ADDENDUM No. 3

ITB No. 4496

West Liberty Reconstruction

SHEET NO. **37 OF 63**

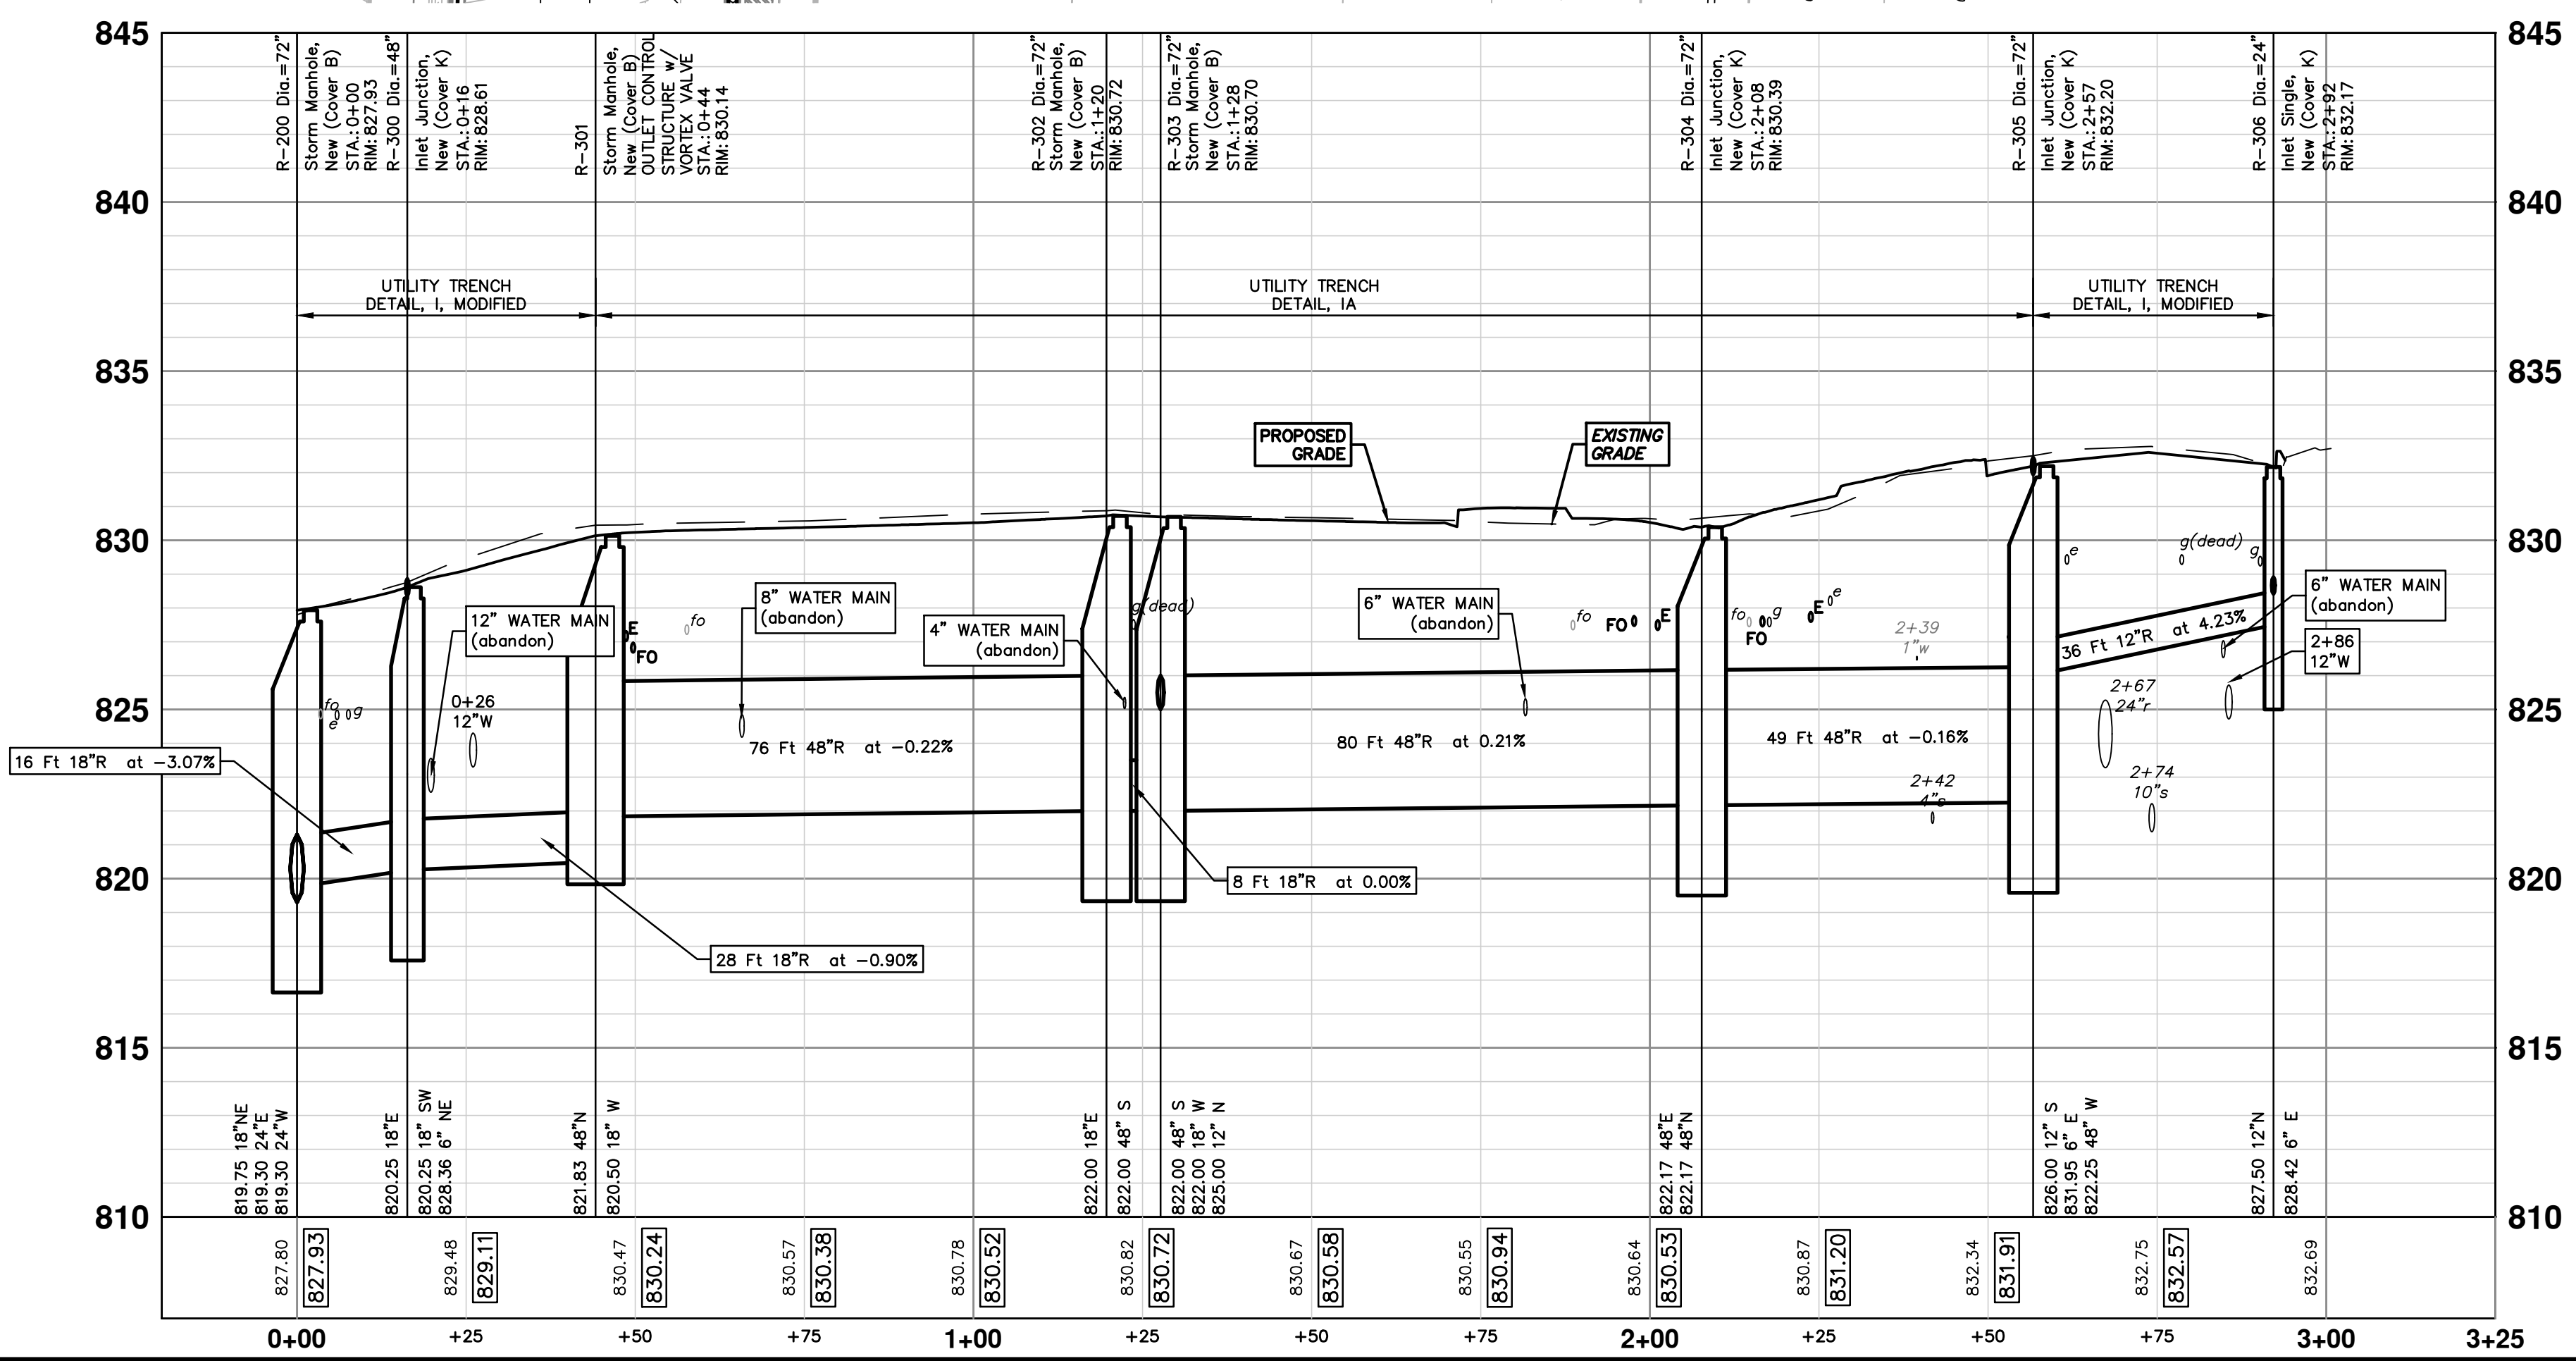
Item #1: Revised plan sheet 37 is included in this addendum. Limits of trench backfill detail IA have been revised.

1. There are no pay item(s) for any of the storm sewer with the "Trench Detail 1A". Please clarify how this pipe will be paid for.
 - Response: Plan/profile sheet 37 has been revised to correct the limits and BF-2 has been revised to contain the correct pay item.
